SUNDRY NOTICES AND REPORTS ON WELLS (DO NOT USE THIS FORM FOR PROPOSALS TO DRILL OR TO DEEPEN OR PLUG BACK TO A DIFFERENT RESERVOIR. USE "APPLICATION FOR PERMIT" (FORM C-101) FOR SUCH PROPOSALS.)		WELL API NO. 30-015-24006

Plug And Abandonment Procedure

BD #001

Eddy County, NM / API 30-015-24006

Proposed Wellbore Diagram

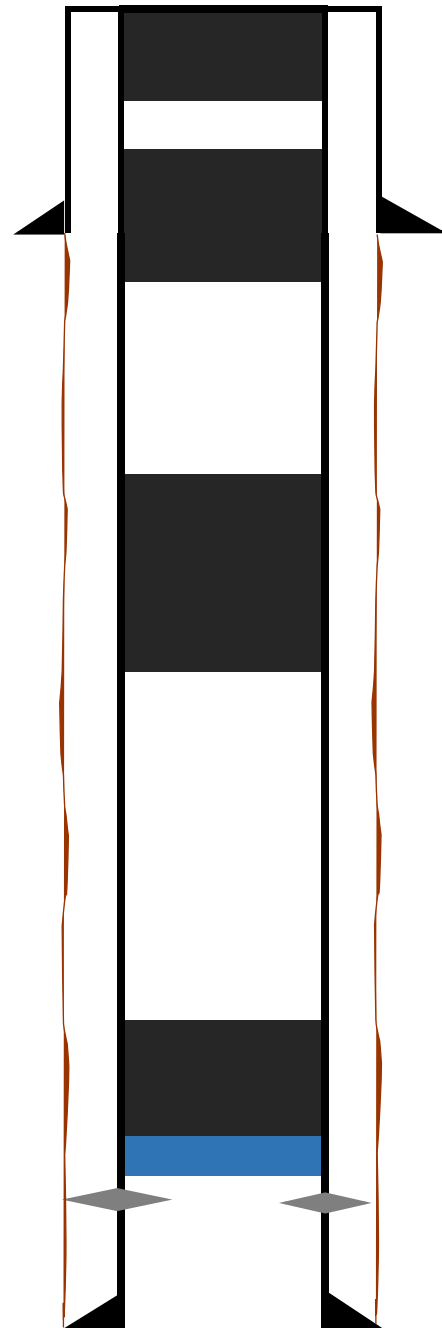
SEE CHANGES TO PROCEDURE

6. P/U 4-1/2" CR, TIH and set CR at +/- 3,956'. Pressure test tubing to 1000 psi. Sting out of CR. Load hole, and pressure test casing to 800 psi. If casing does not test, ~~then spot or tag subsequent plugs as appropriate.~~ POOH w/ tubing.
Find leak in casing before proceeding

Mix 25 sx Type III cement and spot a ~~balanced~~ plug inside casing to cover the San Andres perforations and formation top.

Perf @ 1342' and attempt to sqz. WOC & tag

Mix 25 sx Type III cement and ~~spot a balanced plug inside~~ casing to cover the 8-5/8" surface casing shoe.

Perf @ 386 and attempt to circ cmt to surface

Attempt to pressure test the bradenhead annulus to 300 psi; note the volume to load. If BH annulus holds pressure, then establish circulation out casing valve with water. ~~Mix approximately 25 sx cement and spot a balanced plug~~ from 386' to surface, circulate good cement out of casing valve. TOH and LD tubing. Shut well in and WOC. If BH annulus does not test, then perforate at the appropriate depth and attempt to circulate cement to surface filling the casing from 386' and the annulus from the squeeze holes to surface. Shut in well and WOC.
